Enclosure 6 to E-54257

**SAR Changed Pages
(Public Version)**

**Figure 2-3
Proposed WCS CISF 5-mile Radius**

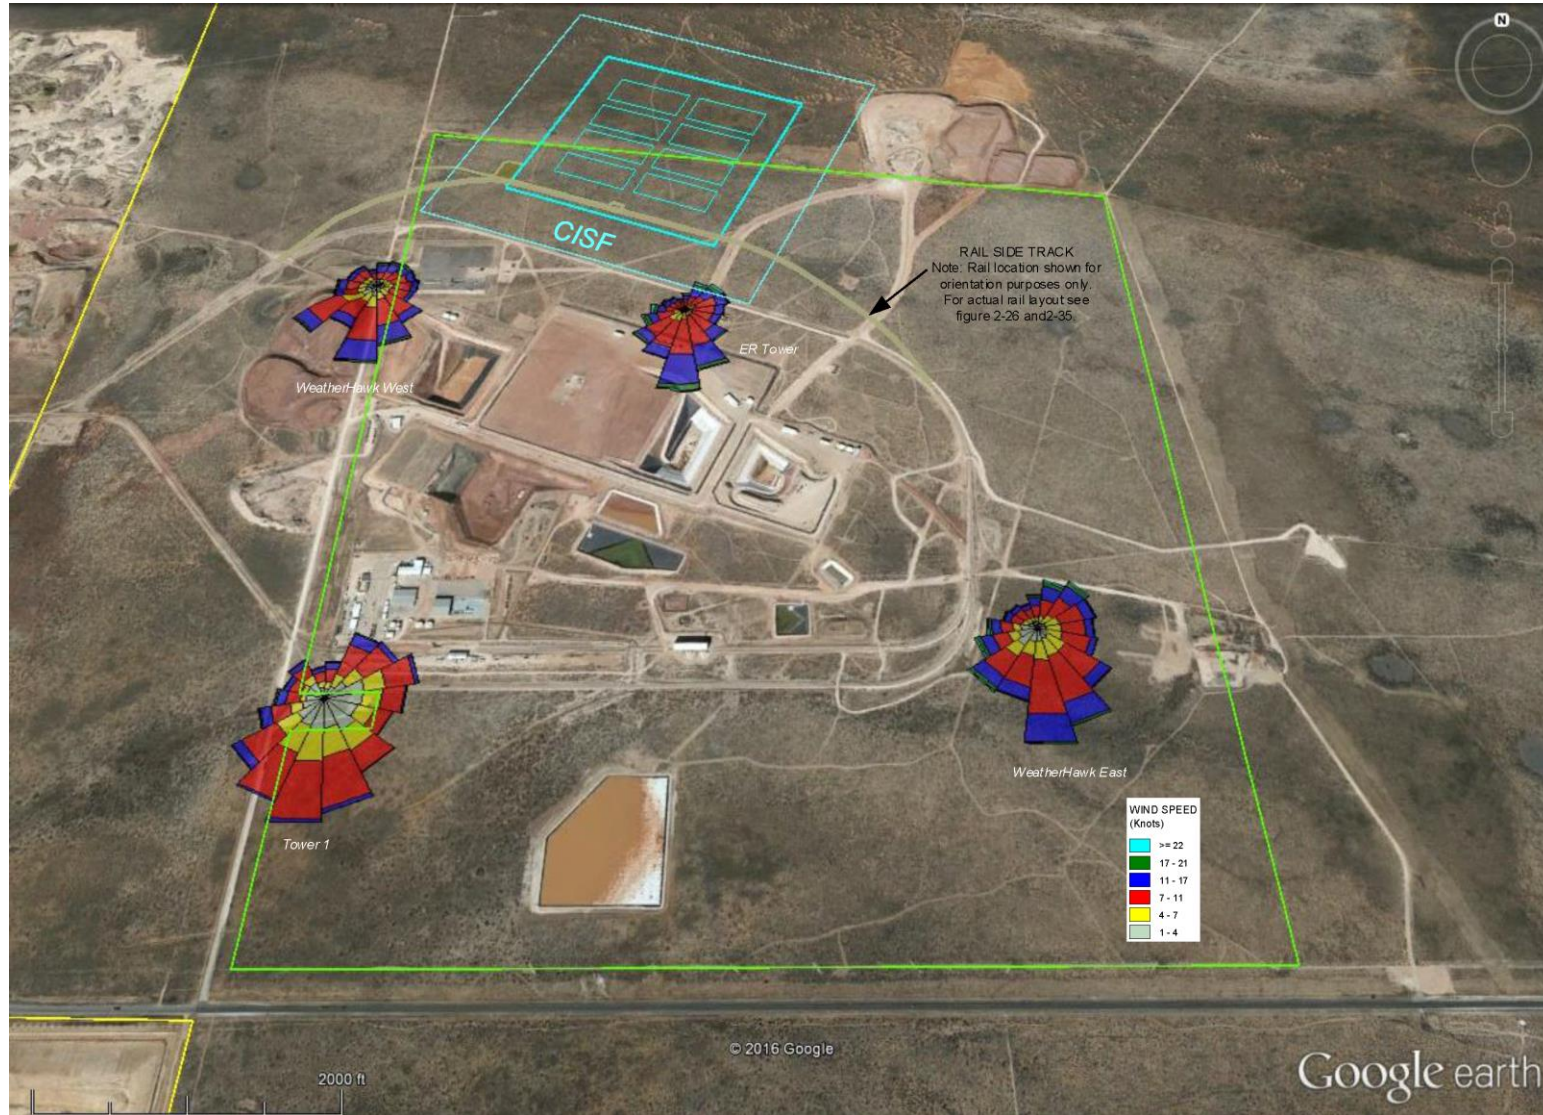
The only industrial facilities located within *five* mile of the WCS CISF boundary are URENCO USA, Permian Basin Materials, *the Lea County landfill, a future travel stop* and Sundance Services, Inc. (Figure 2-3). URENCO USA is a uranium enrichment facility that uses centrifuge technology to provide uranium enrichment services. Waste Control Specialists operates several permitted and licensed facilities immediately south of the WCS CISF, including a RCRA landfill, a low-level radioactive waste facility and a byproduct materials landfill. *The WCS Facilities include several fuel (diesel, gasoline, and propane) tanks used for fueling heavy equipment and facility operations. Tanks range in size from 350 gallons to 8,000 gallons.*

The Waste Control Specialists rail spur and loop exits the Texas & New Mexico Railway near Eunice, New Mexico as shown in updated SAR Figure 2-3. This spur continues east until it reaches the existing Waste Control Specialists facility where it forms a loop around the facility. The rail side track to the WCS CISF will begin by connecting to the northwest side of the existing loop and terminate by re-connecting at the north side of the loop. This rail line is completely controlled by ISP joint venture member Waste Control Specialists and limited to approved Waste Control Specialists waste shipments and transport casks. Railcars carrying contents with the potential to adversely affect the CISF will not be permitted on the Waste Control Specialists rail spur and loop. Fire and explosion precautions for the WCS CISF rail side track are discussed in Section 3.3.6 of the SAR.
